# Mondol Knit Tex Ltd (9959)

## Alim Knit (BD) (11273)

ACCORD  
on Fire and Building Safety in Bangladesh

## Identified Priority 1 Concerns

## 1<sup>st</sup> Priority 1 Concern

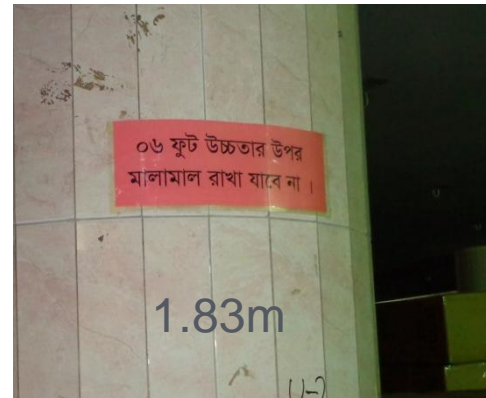
Loading to be reduced for both buildings as storage areas surpass the prescribed limits displayed on signs on the walls.

During our visit, we found that floors used for storage were loaded above the prescribed limits indicated on signs a few columns.

We also noticed that loading varied in weight density. A loading plan would be more appropriate for each floor level.

This concern is applicable for both buildings.

- Verify insitu concrete stresses either by 100mm dia. cores or existing cylinder strength data from 4 columns.
- Detail Engineering Assessment of Factory to be commenced, see attached scope

- Factory engineer to produce and actively monitor a loading plan for all floor plates within the factory complex, with consideration given to slab, column and foundation capacity

- Maintain and enforce the loading plans.

### 1<sup>st</sup> Priority 2 Concern

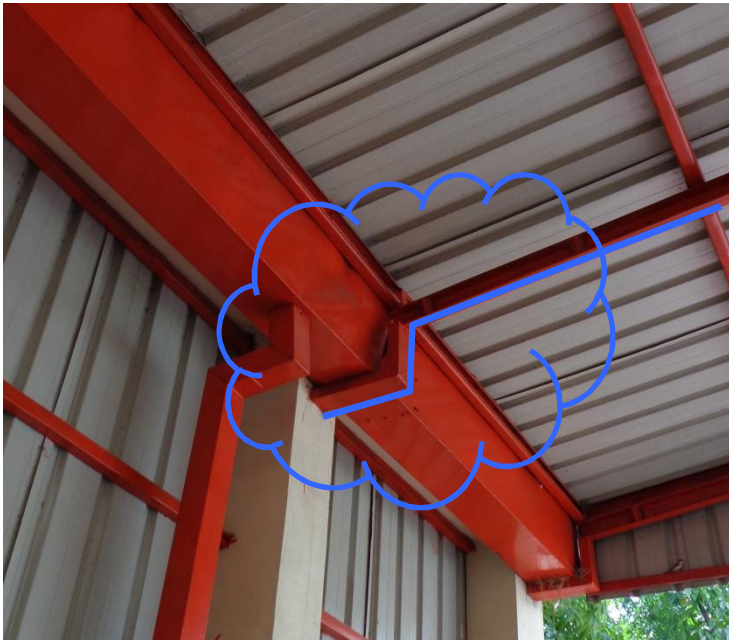
Steel trusses with large tributary areas

During our survey, we found that some steelwork structural framing elements were built and used in an unorthodox way. We require a full detailed engineering assessment of all of the various steel roofs around the 2 buildings.

Supporting member redirected for gutter

- Include in a Detailed Engineering Assessment of the Factory, see attached scope. Assess capacity of connections and steel members of roofs to resist wind forces (down force & uplift)

### 1<sup>st</sup> Priority 3 Concern

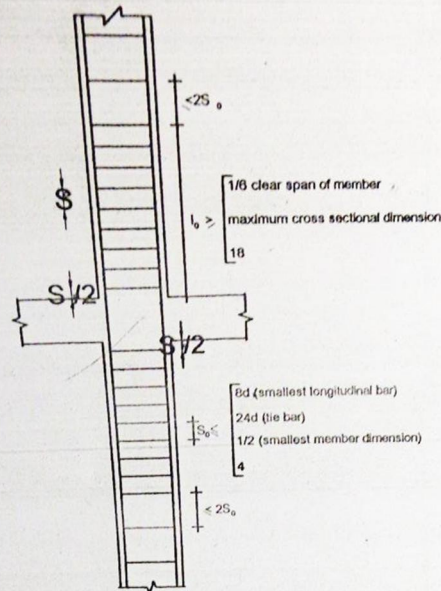
In certain areas of all floors, mainly in office spaces, we found old floor openings covered by flimsy aluminium plates.

- Replace with thicker panels designed for 3 kPa floor load. Securely fasten to floor.

28. CONFINEMENT REQUIREMENTS OF COLUMN AT JOINTS  
FOR EARTHQUAKE LOADING

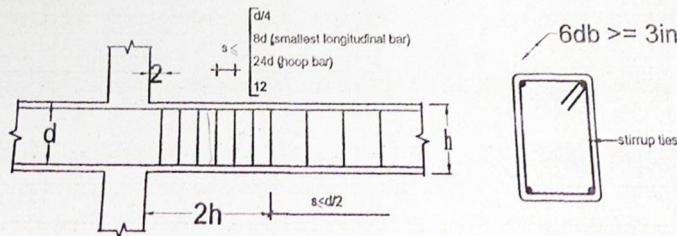
The overall stability of both buildings is provided by a moment frame action which requires special detailing at the beam to column connections. Such details were included on the construction drawings.

The moment frame for Building 1 is limited to the perimeter of the building, while Building 2 has beams across the grid in both directions.

We have 2 concerns with regards to the surveyed system. The first one is the fact that both buildings are connected in one bay and do not have a movement joint. This can alter load distribution. The second concern is with regard to the height of the first floor being close to 6m as opposed to 3.4m. This makes for a fairly flexible moment frame system.

A Detail Engineering Assessment should be carried out to assess both systems.
